**Addendum**  
**Environmental Impact Study**  
**Cielos de TARAPACÁ**

**Valhalla Energy**

**July 2015**

Figure 2: Location Area

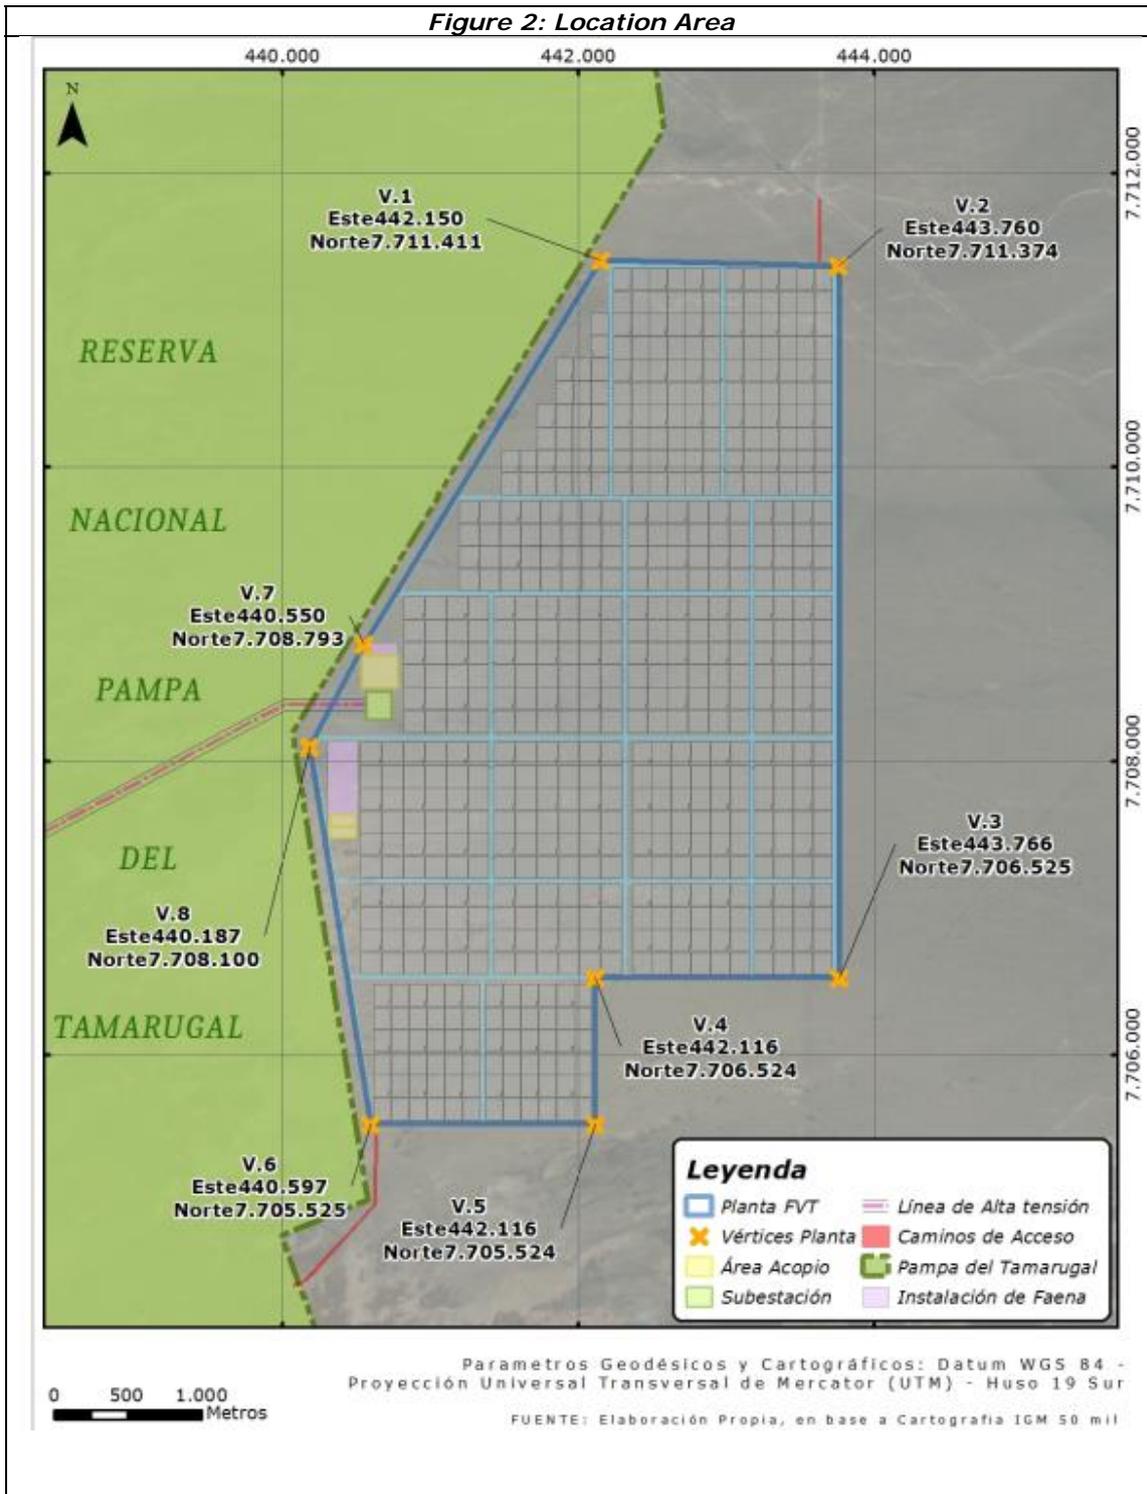
- 9. In the area of site of the photovoltaic park was detected an overlap with the land of the National reserve Pampa del Tamarugal, since the vertex H (coordinates UTM WGS84:440,116 East and 7,707,964 north) of the Solar Park, would be within the limits of The reservation. With regard to this situation it should indicate the cartographic basis used to construct the plans of the Solar Park, clarifying such situation on the basis of the official information.**

The coordinates of vertex H presented in the EIA corresponded to 440,116 east; 7,707.964 North. Chord With the adjustment made to the west limit of the photovoltaic park, in The image presented below The Coordinates have been modified and will correspond Now to the point located in 440,187 This and 7,708,100 North (Vertex V8 In Figure 2).

For the above, To this day There is full certainty that no vertex of the final polygon would be within the national reserve. Complementing The indicated, in The following figure is Evidence That there will be no overlap with the terrain of the Reser it goes national Pampa of the Tamarugal.

**Figure 3: Modification of the section of LAT, due to the existence of areas of REFOSubtraction of *Prosopis Tamarugo***

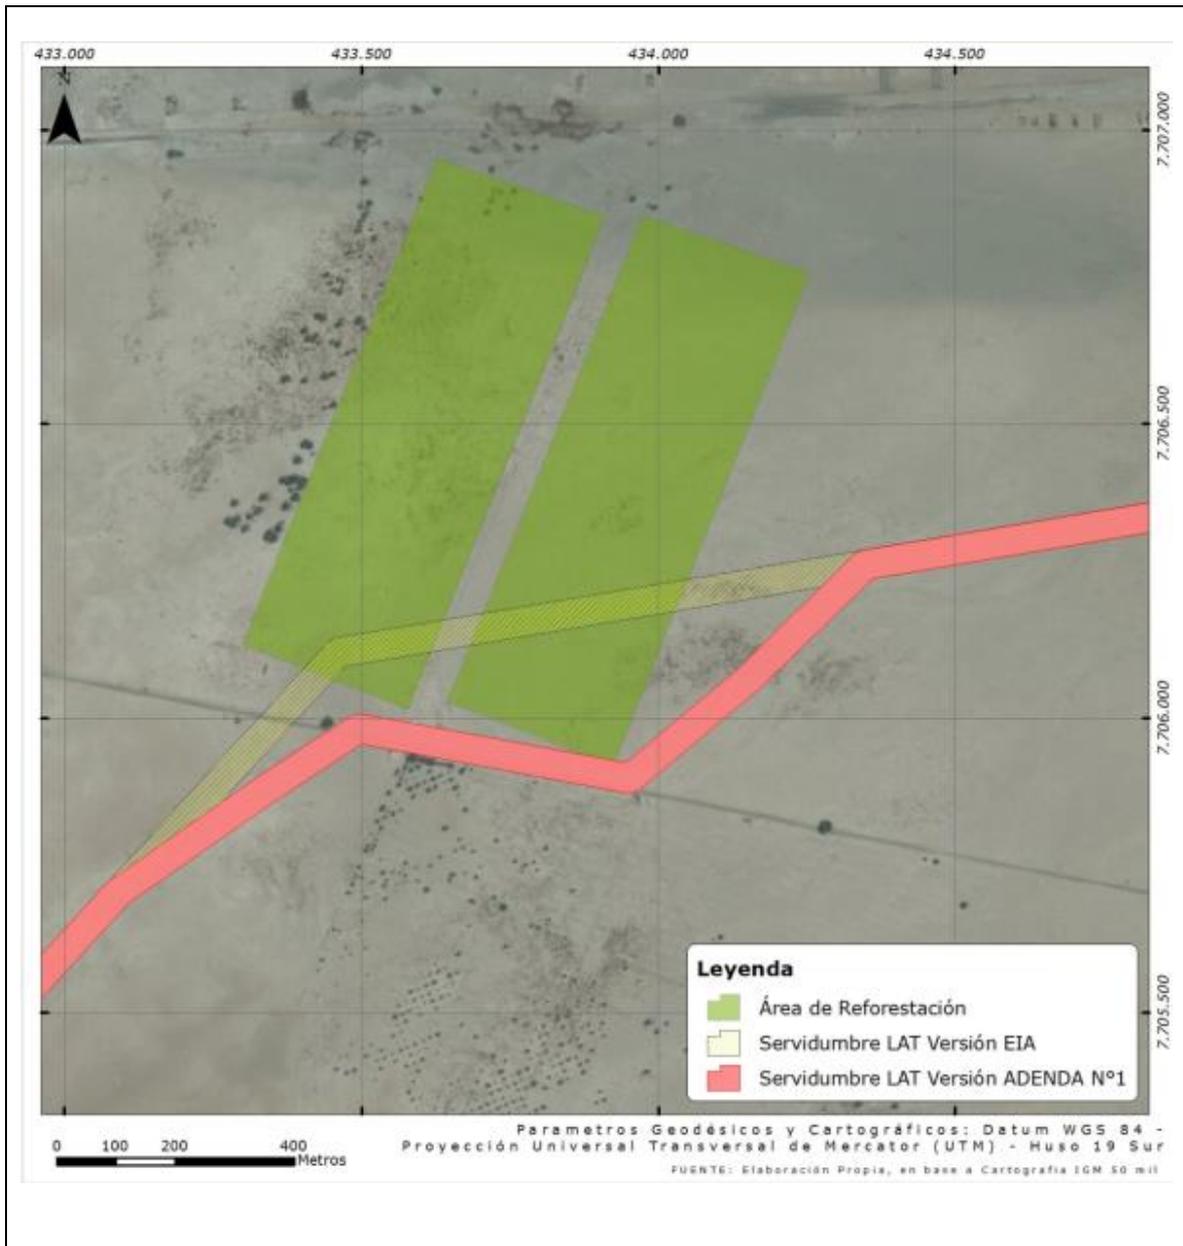
10. The headline indicates in the day that a part of the transmission line crosses the National reserve Pampa del Tamarugal. In this regard, it is reported that CONAF has carried out evaluation in the field of the route of the transmission line, verifying that according to the location coordinates of the towers 34 and 35, they would be in an area destined to reforest with the species *Prosopis Tamarugo*, during the year 2015. Therefore, the proprietor should consider an alternative route of the transmission line, avoiding the reforestation area mentioned.

Given the Present Observing the authority, he proceeded to carry out a new field campaign, Between the days 27 and April 30, 2015, in which he traversed Again The whole area of the project, detecting A plantation of Tamarugos Carried out during the first months of 2015.

For the foregoing, and in order not to affect any specimen of the species, whether natural or planted, a change in the path was made of the High Voltage line (LAT). This new design of LAT considered as restrictive variables the presence of specimens of *Prosopis Tamarugo* (natural or planted) and the reforestation areas of the species in question (both carried out and those scheduled to be carried out during this year). In this way, The new design considers the displacement of 4 structures (towers) and the construction of an additional tower at the 60 originally contemplated, that is to say, this new design will have a total of 61 structures.

Figure 3 shows the modification of LAT, due to the existence of the reforestation areas of *Prosopis Tamarugo*. It is important to note that TAnto in the construction of the towers as in the path of access and maintenance of the line of high tension, it is not Affect No specimen, whether planted or natural *Prosopis Tamarugo*.

Figure 4: Vertices Of Project Area

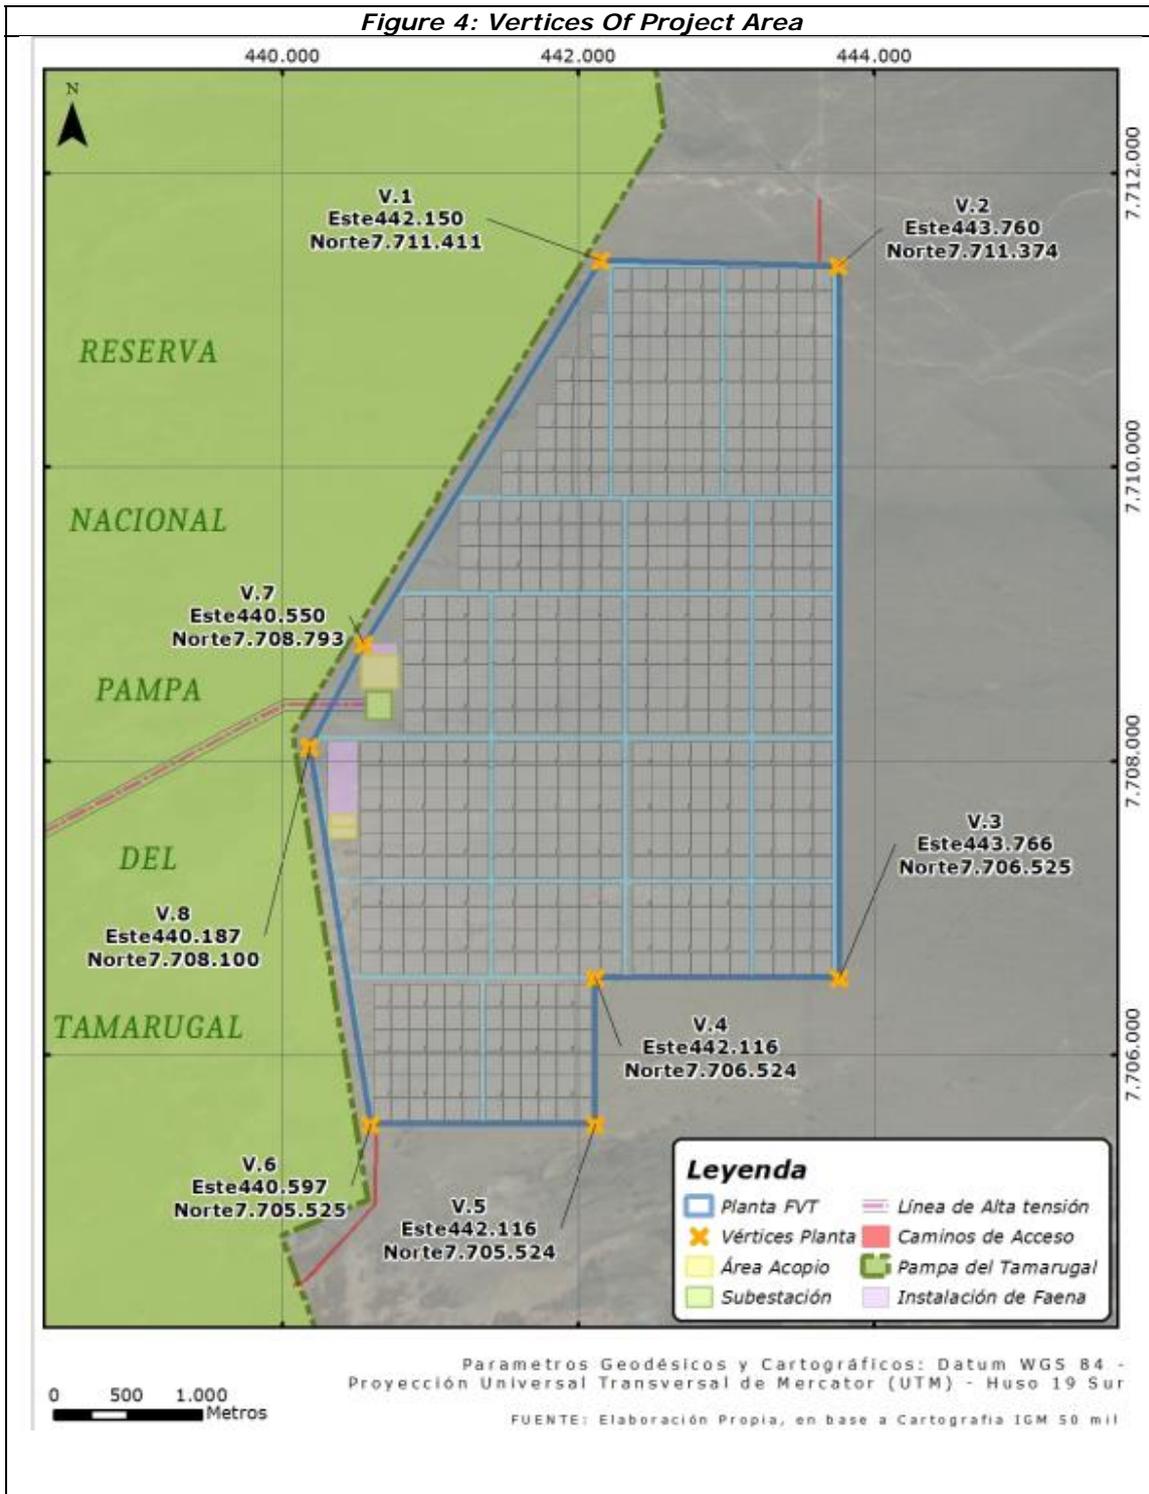
**12. The holder shall consider a road of circulation between lot N ° 3 of the Pampa del Tamarugal National Reserve and the photovoltaic plant. The above, by way of safeguarding this protected area.**

The observation made by the authority is welcomed. As already noted in the response N °9 Precedent, SE Reiterates that as To the request made by national property, Within the framework of the process of the concession of onerous use, a strip of 100 m will be left with respect to the limit of the Pampa del Tamarugal National Reserve and the project in evaluation, In order to allow the circulation of third parties for that strip. This means a reduction of the total surface of the photovoltaic park from 1,614 ha to 1,567,67 Has, and the Reorganization of works in the project area, As shown in the Figure 4. Under this modification, Application of PAS 160 is adjusted (Attached In The Observation No. 6 of Title V of this Addendum). According to the above mentioned, has been adjusted In addition The plan of application of the concession of onerous use of the area of the photovoltaic park.

Figure 8: Permanent works of the project

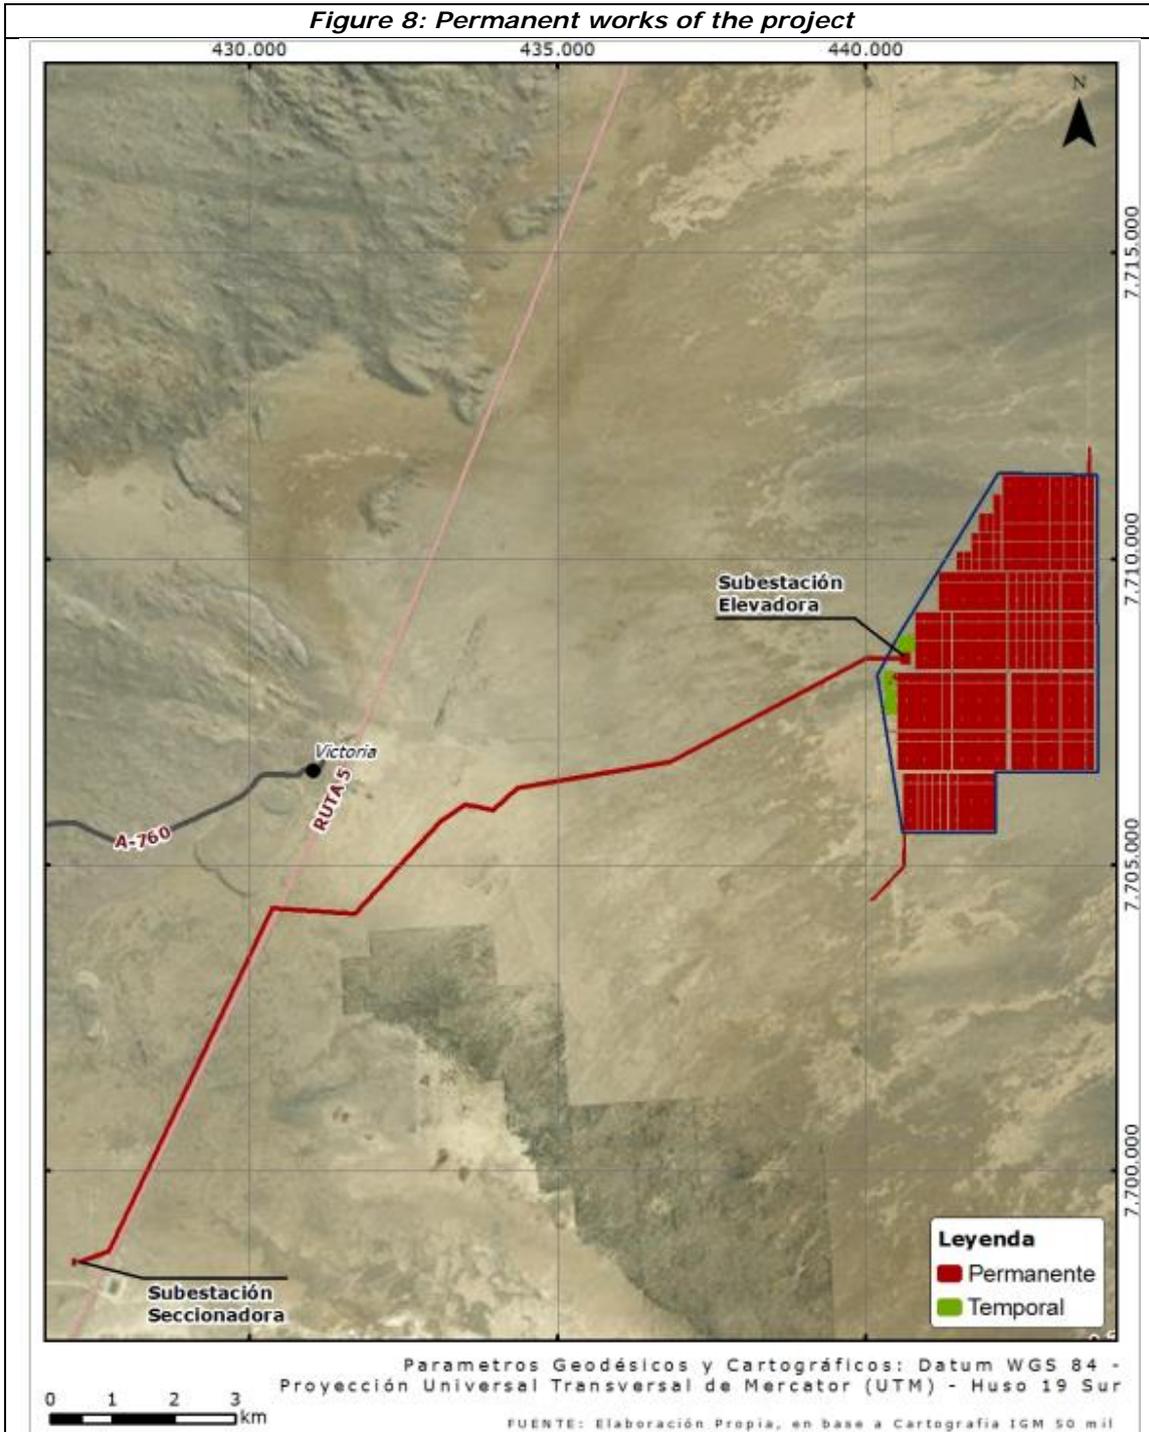
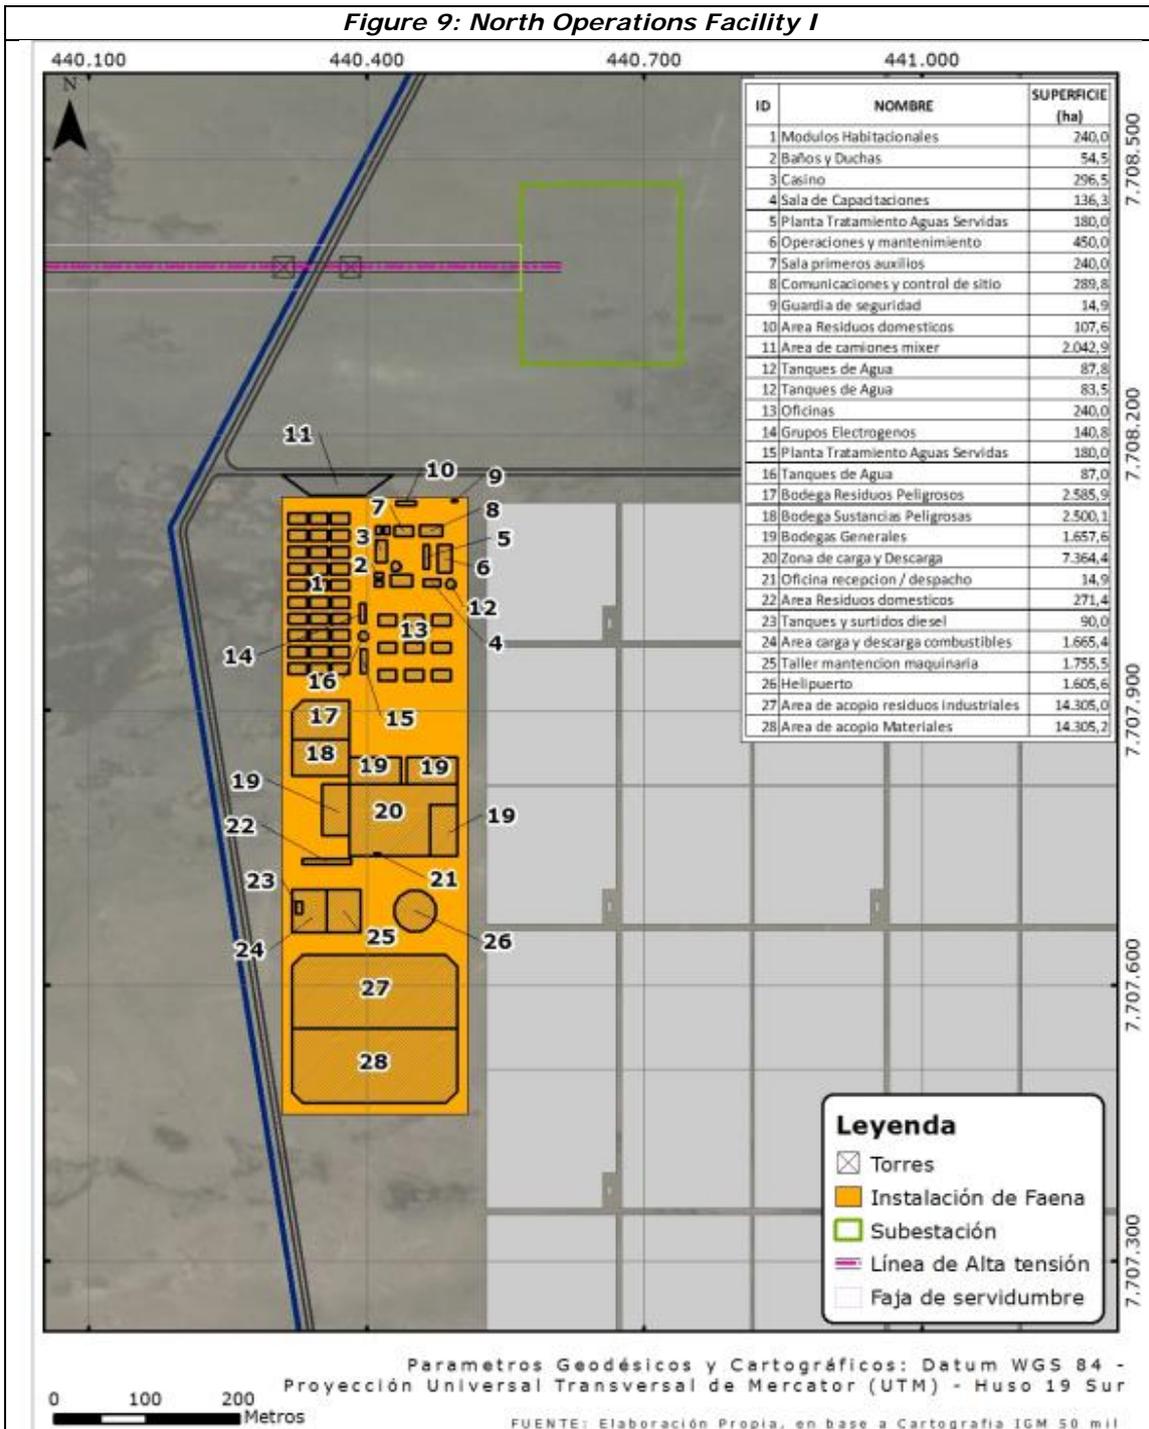
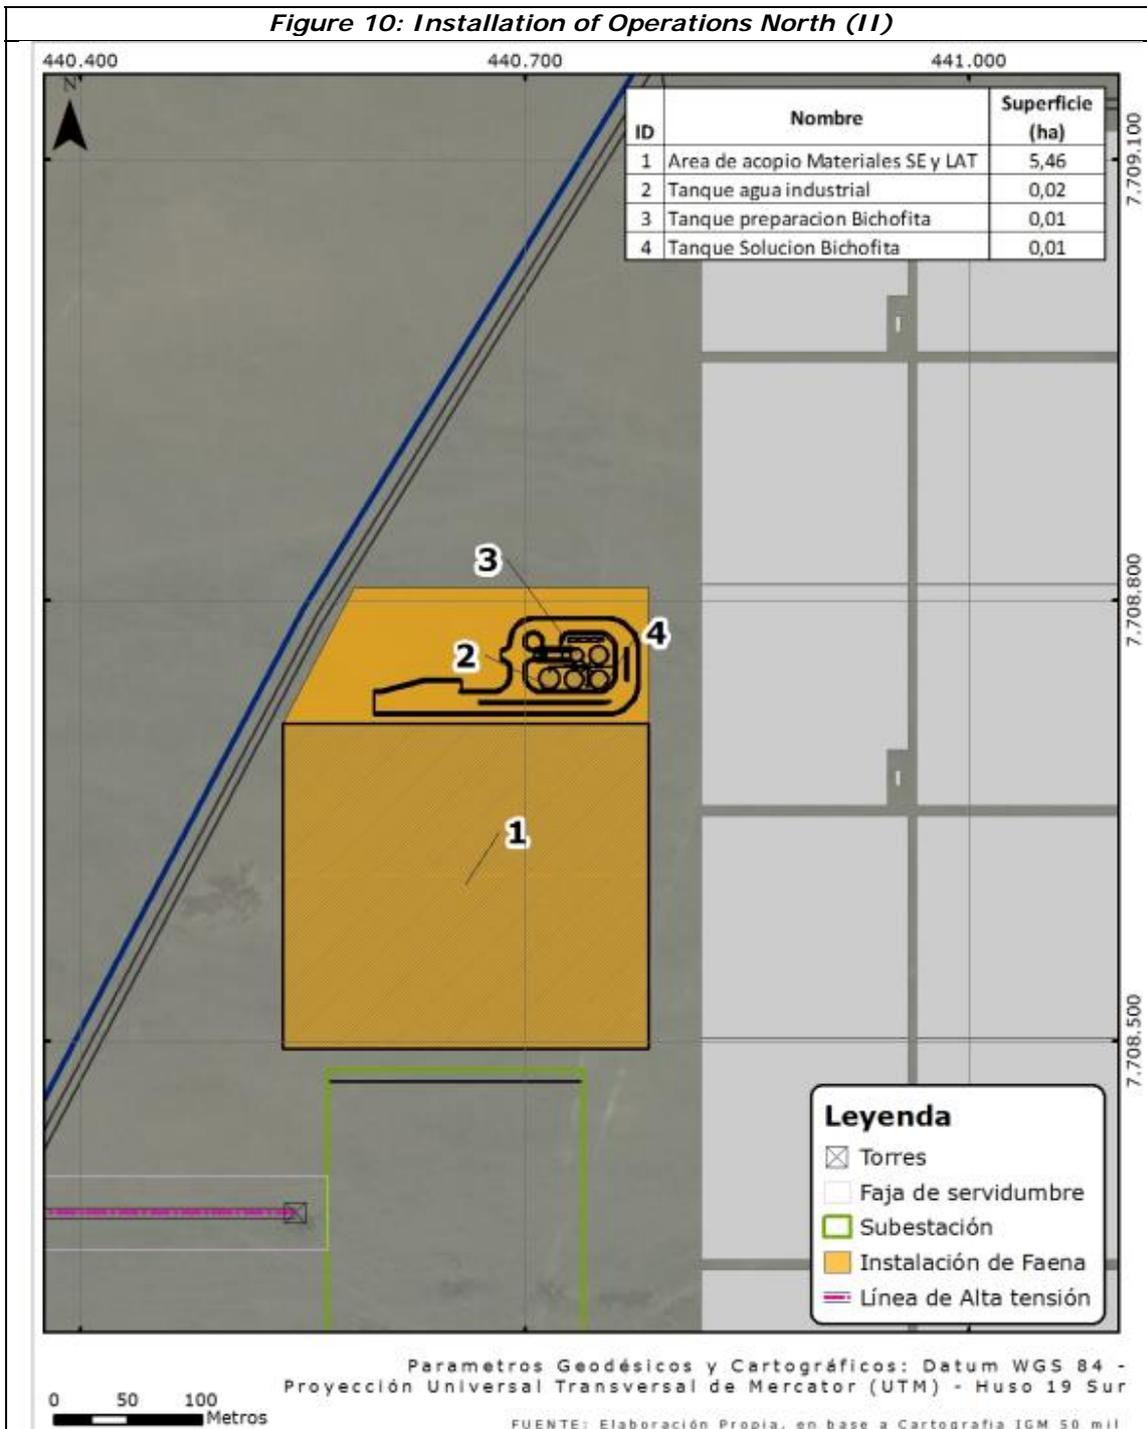
16. The proprietor shall clearly indicate the facilities associated with each of the stages of the Project, describing the closing activities when appropriate. The above, in order to To clarify what facilities will be maintained throughout the implementation of the Project (Casino, camps, baths, wineries, etc.) and which will be temporary.

(\*)ID according to Figure 9 And Figure 10

Below are Figures With the dependencies of the Permanent works and temporary works, for a greater understanding.
